Bala generating station: Creates risks to the Township

Risks to the Township remain

Inadequate public safety measures

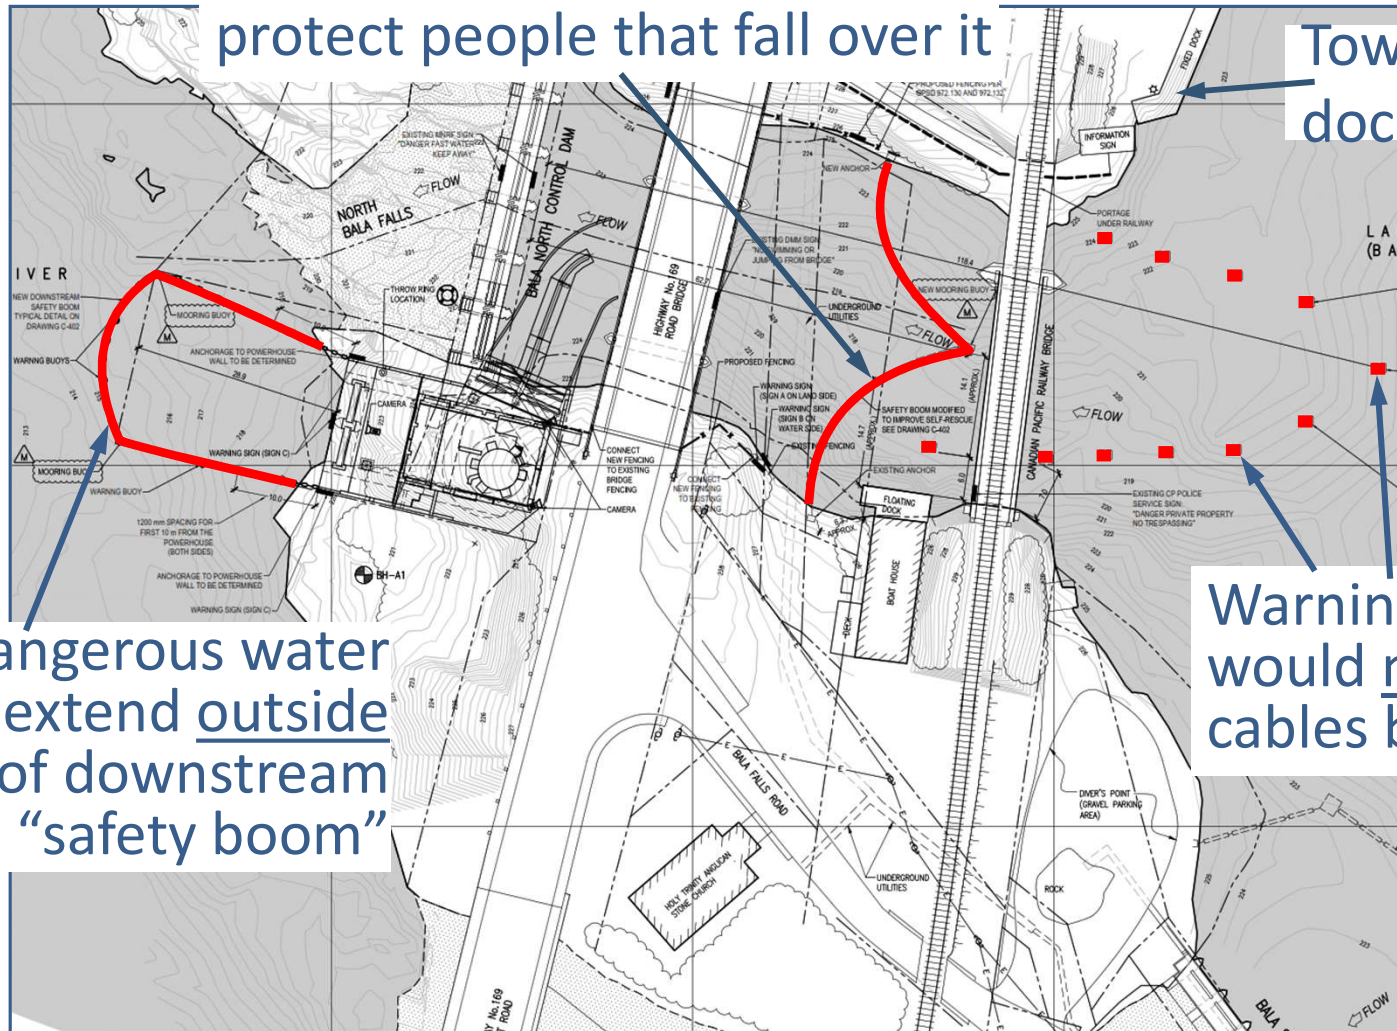
Upstream “safety boom”
would tip canoes, and not
protect people that fall over it

Township's
docks

Warning signs
would not have
cables between

Dangerous water
would extend outside
of downstream
“safety boom”
